December 16, 2022

Department of Water Resources Attention: Delta Conveyance Office P.O. Box 942836 Sacramento, CA 94236-0001

RE: Comments on Delta Conveyance Draft Environmental Impact Report

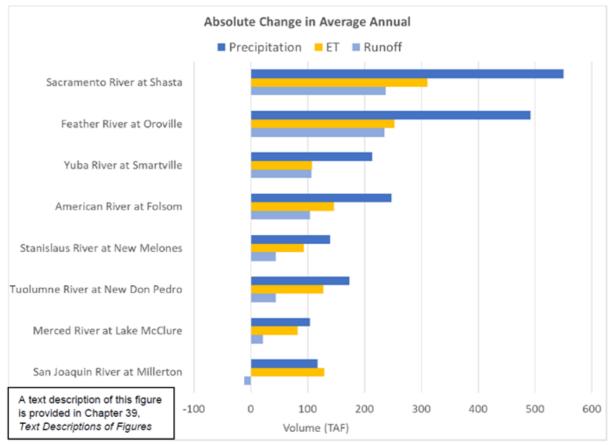
The DEIR's assumptions regarding climate change and sea level rise, including in the No Action Alternative 12 and 2040 modeling, fail to provide adequate and accurate information to decisionmakers and the public regarding the risks and likely environmental effects of operations of the proposed project. While the DEIR claims that it uses "a conservative climate change and sea level rise assumption," DEIR at 4-5, in fact the DEIR uses what it admits are an "extreme" assumption regarding sea level rise, *id.*, Appendix 3C, at 3C-10. Moreover, the DEIR's modeling assumptions predict that climate change will increase runoff compared to the historical record – **a hotter, wetter future** – even though the text of the DEIR and other state documents predict climate change will result in reduced precipitation and runoff, more frequent and severe droughts, and **a hotter, drier future**. As a result, the DEIR's modeling and quantitative analysis fails to adequately account for the likely effects of climate change, and dramatically underestimate those effects, resulting in inaccurate and misleading quantitative analysis of the effects of the project in light of the likely effects of climate change in the appendices and No Action Alternative.

First, instead of using the most probable estimate of sea level rise, the DEIR's No Action Alternative instead uses an "extreme assumption" of 1.8 feet of sea level rise by 2040, which the State admits has a less than a 0.5% chance of occurring by 2040. DEIR, Appendix 3C at 3C-10; Ocean Protection Council, State of California Sea-Level Rise Guidance, 2018. As a result, the model assumes more flow through the Delta is necessary to maintain the hydraulic salinity barrier, resulting in higher flows into the Delta and lower reservoir storage. *See* DEIR at 30-25. In contrast, the State's median projection of sea level rise is 0.6 feet by 2040. Ocean Protection Council 2018.

Figure 30A-3. Projected Changes in Precipitation, ET, and Runoff for Major Watersheds in the Sacramento and San Joaquin River Basins for 2040 Median, Compared to Historical Reference Period (1995)

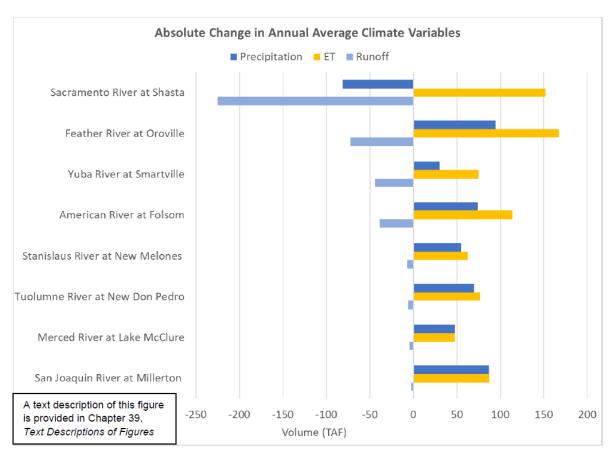
In contrast to the Central Tendency, the DEIR also presents results of the Median climate models, which predicts decreased runoff compared to the historical record:

However, the DEIR does not use the 2040 Median climate change modeling, despite the fact that the median is a better reflection of the "typical" year and is not overly influenced by extremely wet years, as the "mean" (or central tendency) metric is. This median prediction appears more consistent with hydrology over the past two decades. As the DEIR admits, "[i]n the context of climate change, projections of future precipitation are even more uncertain than projections for

temperature. Uncertainty regarding precipitation projections is greatest in the northern part of the state, and a stronger tendency toward drying is indicated in the southern part of the state." DEIR at 5-4. Given this uncertainty, it is irresponsible for the DEIR to assume increased precipitation as a result of climate change (Central Tendency) without equally considering reduced precipitation and runoff as a result of climate change (2040 Median).
